SEWAGE SYSTEM REVIEW

SANTA CLARA COUNTY
DEPARTMENT OF ENVIRONMENTAL HEALTH

Project Description SR No. SR0856496

New 6 bedroom SFR, 2 bedroom ADU, Pool cabana w/half bath (>2 water fixtures), detached garage w/no plumbing, new swimming pool

PLOT PLAN

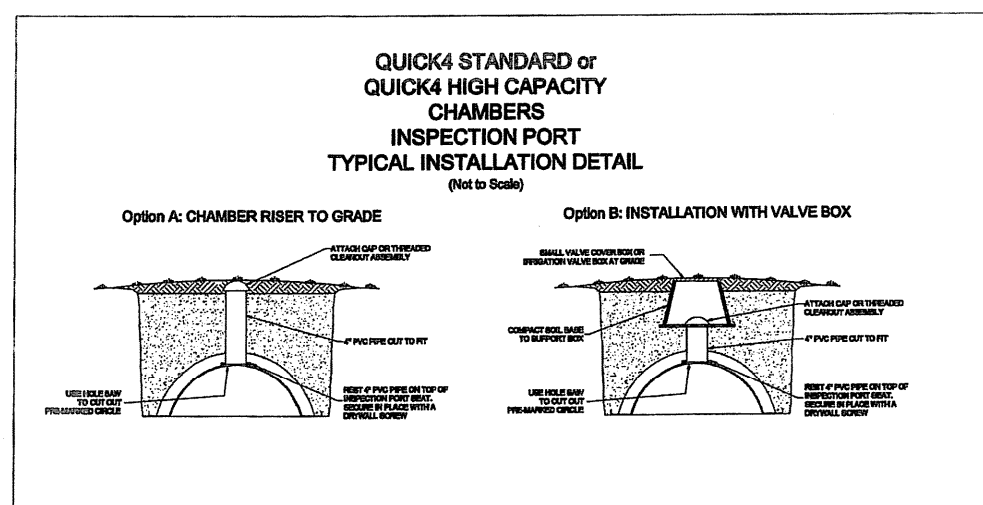
Install new 2,000 gal tank w/D-valve, 609' + 609' leach field with Infiltrator Chamber system. Traffic rated tightline to be installed beneath driveway area
